What Physics Needs from RF/SRF (CEBAF)

Corrected by Tom Powers

Additions at beginning 25 Jan 2021 Jay Benesch

Klystron Power C50 Shape

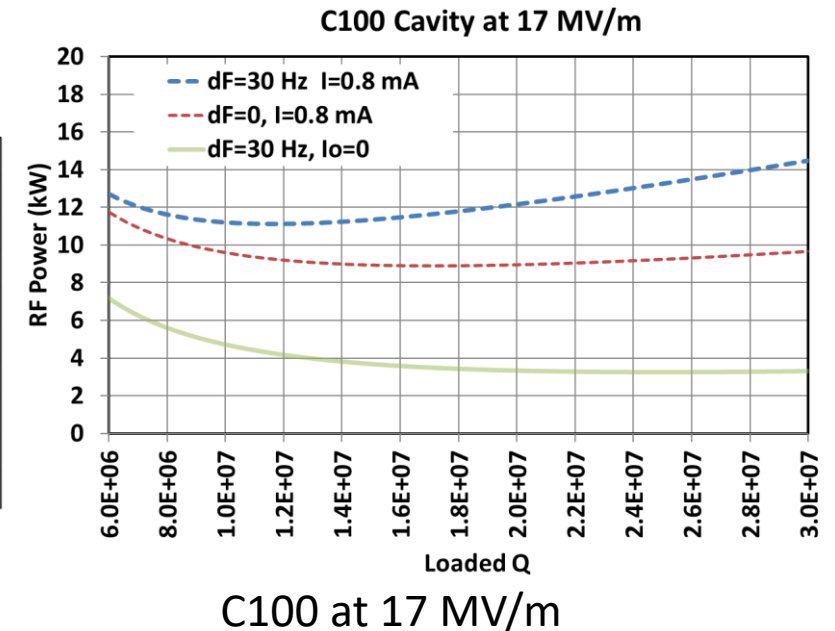
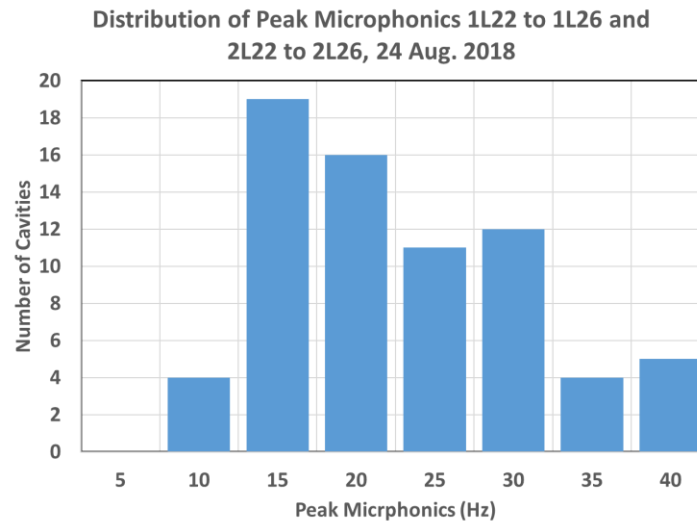
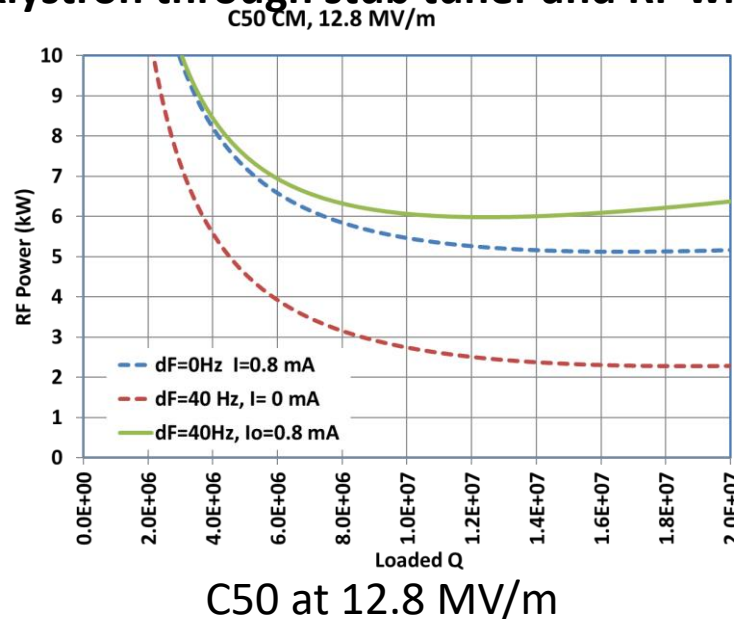
- Needed: ~~$0.25 * L(E + IR_c)^2 / R_c$~~ Jay forgot microphonics and detune budget

$$P_{RF} = \frac{L}{4R_c} \left\{ (E + IR_c)^2 + \left(2Q_L \frac{\delta f}{f_o} E \right)^2 \right\} \quad R_c = Q_L(r/Q)$$

- Assume coupled impedance $R_c = 1.25E10\Omega$, $L = 0.5m$, $\delta f = 40$ Hz, $(r/Q) = 960$, $Q_L = 1.3e7$,
- DeltaF based on measured values in 1L13 for C75/C50 CM.
- At 12.3 MV/m, $P = 6.2$ kW.
- At 15 MV/m, $P = 8$ kW ~~$P = 0.125 * (1.5E7 + 0.8E-3 * 1.25E10)^2 / 1.25E10 = 6.25kW$~~
- At 20 MV/m, ~~$P = 9$ kW~~ $P = 11.8$ kW
- ~~driving existing form factor tubes harder~~
- For 15 MV/m this means buying new 8 kW tubes and upgrading the zones at
 - \$50k per zone assuming we are using the standing order for the tubes,
 - \$450k if we order new tubes independently.
- For 12 MV/m this means spending \$5k per zone and completing the main distribution panel upgrades in order to get 6.5 kW.

Comparison of required RF power as a function of loaded-Q for C50 cavities operated at 12.8 MV/m and 15 MV/m with 0, 20 and 40 Hz detune allowance.

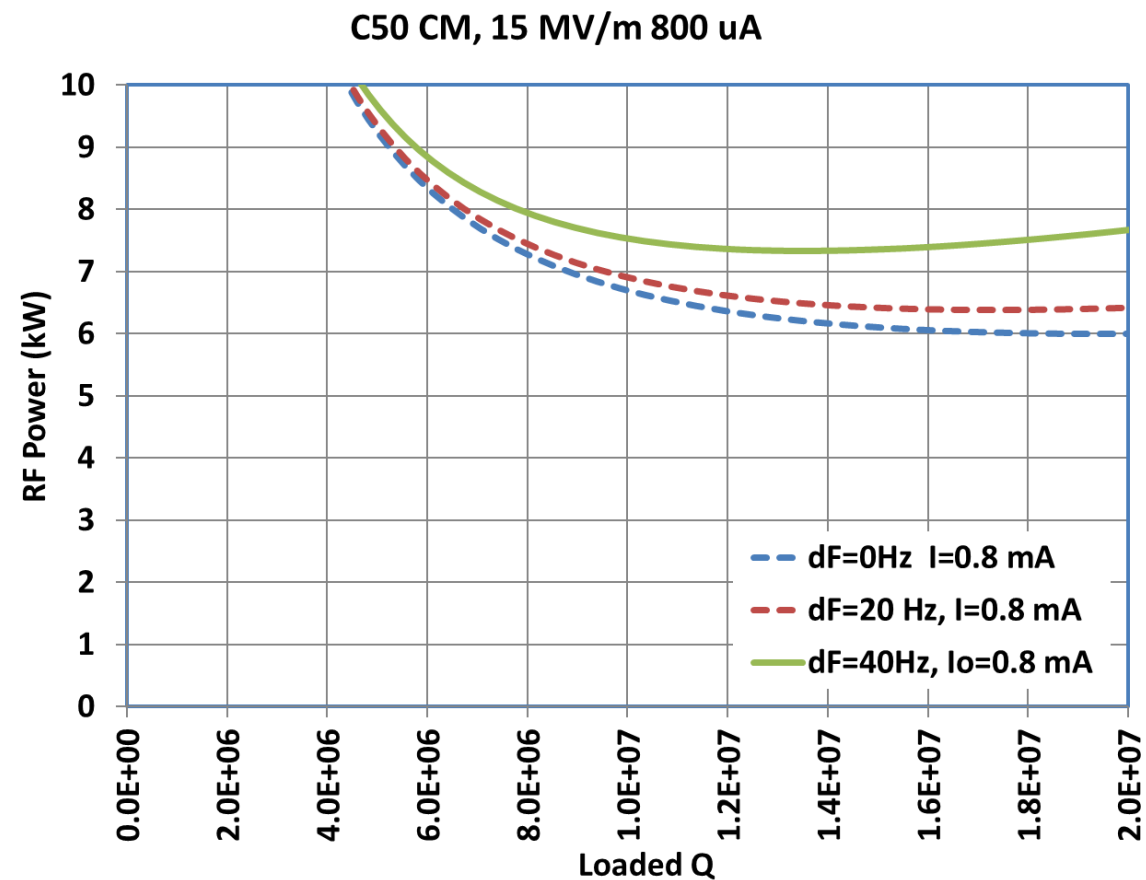
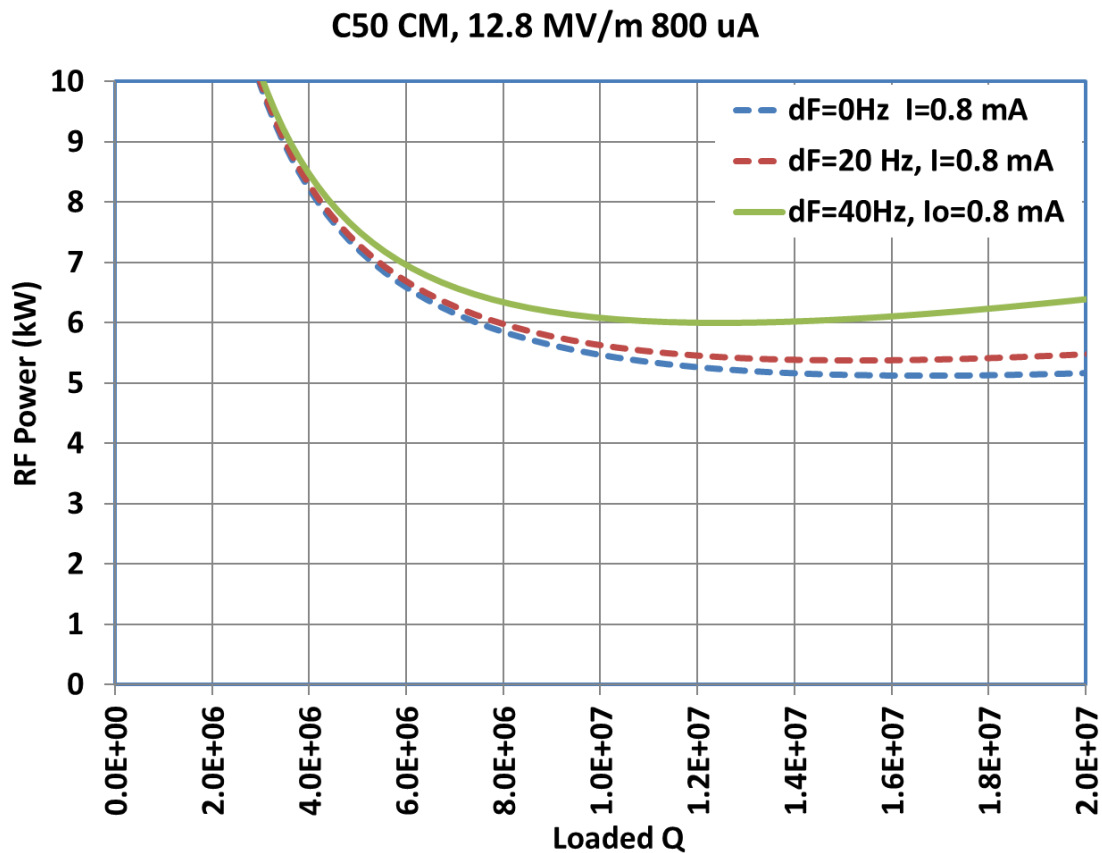
- Cavity 1 and 2 are C75 cavities.
- These were sets of 3 minute measurements which probably missed peak excursions which occur from time to time in the machine.
- You have to add some extra detune margin to account for
 - The tuner algorithm dead band of 5 to 10 degrees.
 - Our ability to accurately set the detune offset.
 - Known and unknown sources such as turbo pumps.
